TECHNICAL BULLETIN
Bell Helicopter **TEXTRON**

No. 214ST-02-171

MODEL AFFECTED: 214ST

SUBJECT: INTRODUCTION OF NEW TAIL ROTOR BLADE
RETAINING BOLT AND WASHER HARDWARE.

FIGURE 1

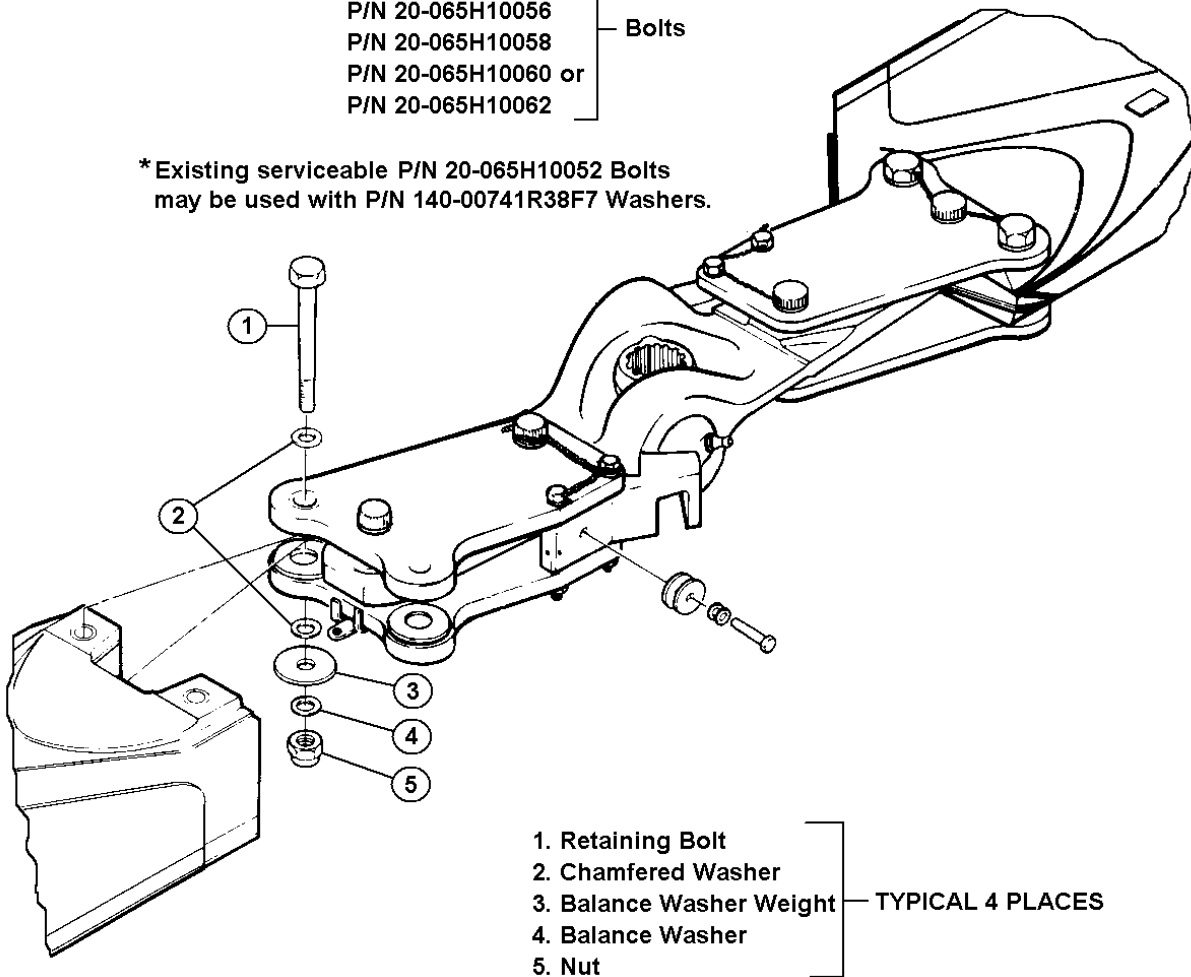
Service experience indicates that certain combinations of existing tail rotor blade retaining bolt, P/N 20-065H, and washer, P/N 140-007-41, hardware on the P/N 214-011-801 Tail Rotor Hub Assembly could create an interference between the washer's inner diameter and the bolt head radius. New hardware has been identified which removes this interference when properly installed.

1. Refer to Figure 1. Replace existing tail rotor blade retaining bolts, P/N 20-065H10048, 20-065H10050, and 20-065H10052, and washers, P/N 140-007-41-38C4, as a unit if either the bolt or washer are unserviceable or if there is evidence of interference between the washer and the bolt head radius. To aid in choosing the correct hardware, washer thickness and bolt grip length are provided in Tables 1 and 2.

- c. Install large balance washers (Figure 1, item 3), when required, between the P/N 140-007-41 Washer (item 2) and the retaining nut (item 5) with the heaviest balance washer against the P/N 140-007-41 Washer. When required install item/s 4 between items 3 and 5. For nut torque and safetying requirements refer to the 214ST maintenance publications.

Replace existing: P/N 140-007-41-38C4 Washers and
P/N 20-065H10048
P/N 20-065H10050 or
P/N 20-065H10052* } Bolts

As a unit with: P/N 140-007-41R38F7 Washers and
P/N 20-065H10052*
P/N 20-065H10054
P/N 20-065H10056
P/N 20-065H10058
P/N 20-065H10060 or
P/N 20-065H10062 } Bolts

- a. Following initial installation as a unit, the P/N 20-065H10052, 20-065H10054, 20-065H10056, 20-065H10058, 20-065H10060, or 20-065H10062 Bolts and the P/N 140-007-41R38F7 Washers may be replaced individually as serviceability dictates.

- b. Existing P/N 20-065H10052 Bolts may be used with new P/N 140-007-41R38F7 washers as long as the existing bolts meet serviceability criteria. Refer to the 214ST maintenance publications.

*Existing serviceable P/N 20-065H10052 Bolts
may be used with P/N 140-00741R38F7 Washers.
